Visual differences of the tensioning pulley 531 0565 30

LuK AS Part No.: 531 0565 30

As part of the ongoing development of our products, the tensioning pulley **531 0565 30** has been modified.

Fig. 1: 531 0565 30 (old version)

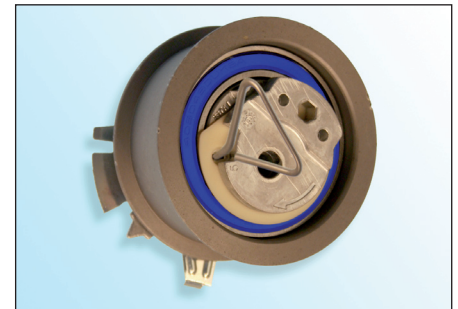
- Cam made from sinter metal
- Surface coat E-Coat (black)
- Blue bearing seal

- Cam made from cast aluminium
- Surface coat Zinc phosphorous (light brown)
- Brown or blue bearing seal

The „old version“ of the tensioning pulley is **not** made completely redundant and can still be used and assembled in accordance with the instructions provided by the manufacturer!

When assembling the „new version“, ensure that the surface coat of the tensioning pulley is **not** damaged!
